REGIONAL REVIEW NOTIFICATION

ARC REVIEW CODE: R1801182

Name of Proposal: Southpoint Farms Logistics Center (DRI 2759)

SOUTH POINT FARMS LOGISTICS CENTER DRI
City of Union City
Natural Resources Group Review Comments

DRI SITE PLAN

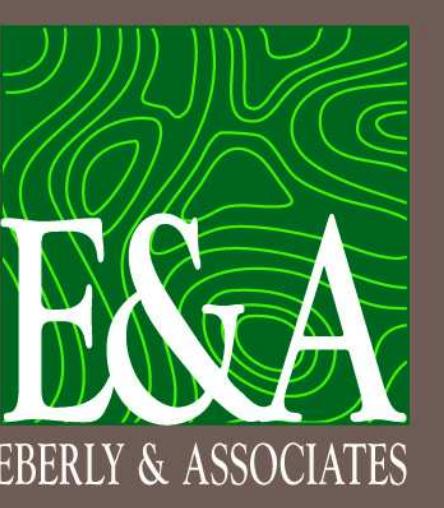
Both the USGS coverage for the project area and the submitted site plan show a blue-line stream, Line Creek, running along the eastern and southern boundaries of the project property. The site plan also shows an intermittent tributary to Line Creek originating on the property. Two dashed red lines roughly follow the paths of both streams, but they are not a consistent distance from the streams and are not identified as buffers. The buffers should follow the streams consistently and should be labelled. The buffer depths should be shown to indicate that they conform with the Union City Stream Buffer Protection Ordinance, which requires a 50-foot stream buffer and 75-foot impervious setback on all streams that meet the ordinance's definition of a stream. Final determination of the buffer requirement is the City's. In addition, no 25-foot State sedimentation and erosion control buffer is visible along the streams on the submitted plan. It also needs to be shown for applicable streams and other waters of the state on this property.

The development is one building with a wraparound driveway. All driveway allow for both vehicle and freight access. No sidewalk or bicycle facilities are proposed.

The site plan does not provide specific information or depictions of bicycle and pedestrian facilities.

All four site driveways allow for the both vehicle and freight access.
